Subject: Three Mile Island Nuclear Station Unit 1  
Docket No. 50-289  
Revised Specific Heat

This is a final report pursuant to the 10 CFR 50.55(e) reporting requirements in regard to the revision of the Specific Heat Curve for UO<sub>2</sub> fuel.

LOCA LIMITED MAXIMUM ALLOWABLE LINEAR

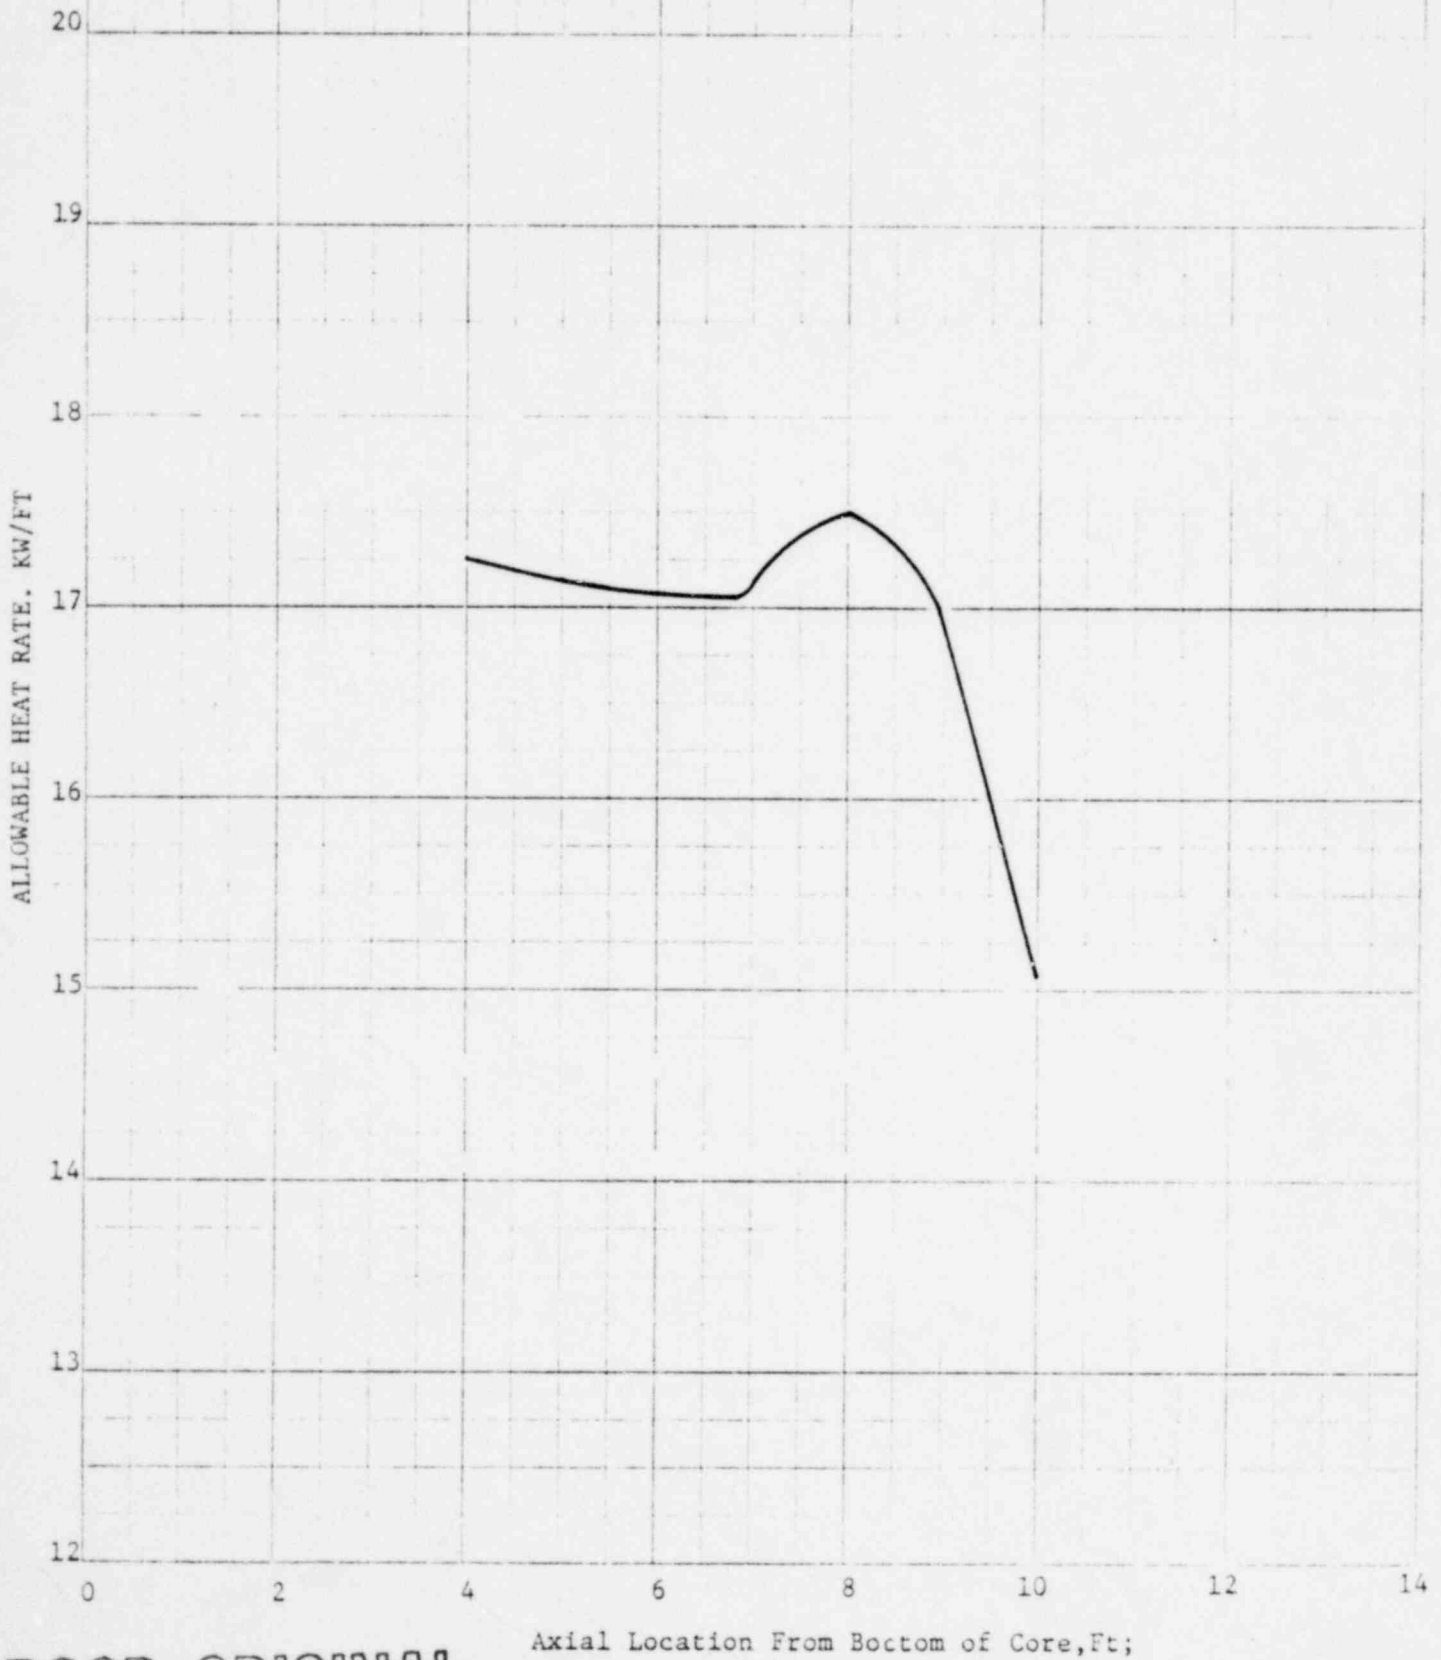
The only significant impact the specific heat revision has on safety limits is the lowering of some portions of the allowable linear heat rate by up to 0.65 KW/ft. This LOCA derived curve determines the allowable linear heat rate as a function of elevation in the core for which the Interim Acceptance Criteria are met. Revised LOCA limits were determined by repeating the Oconee 2 calculations because these analyses are representative of the 177 fuel assembly plants. The allowable heat rate curve on Oconee 2 is lower by 0.65 KW/ft at the six foot elevation, but is unchanged at the ten foot elevation. The revised LOCA limit curve is attached.
